NUMBER: 08-014-04

Radio Intermittent Audio

This bulletin involves applying a label over slots in the radio top cover.

Fig. 1 COVER SLOTS

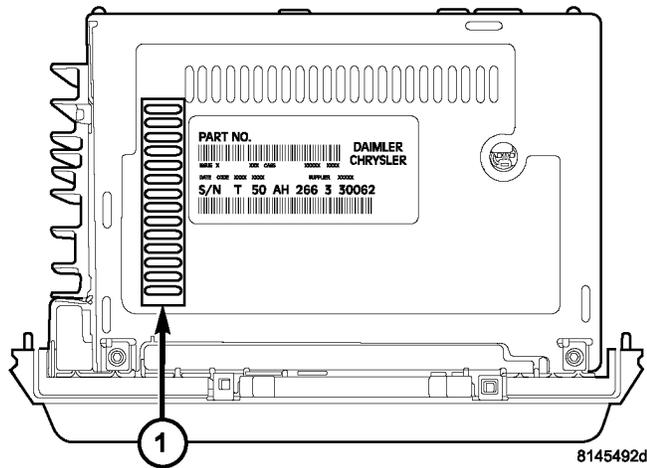
1. Remove radio from Instrument panel. Wiring connectors can remain connected.
2. Place 3M Vinyl Plastic Electrical Tape Super 33+ or Equivalent over the row of slots on the left hand side of the radio top cover, be sure to not cover information (barcode, etc.) on the radio's primary label (Fig. 1). Be sure the slots are covered completely and the tape is sealed all around the edges. Also cover and seal with tape, the two slots between the heat sink and the row of covered slots.

1 - COVER SLOTS COMPLETELY

NOTE: The two slots between the heat sink and the row of covered slots (1) also need to be completely covered and sealed with tape.
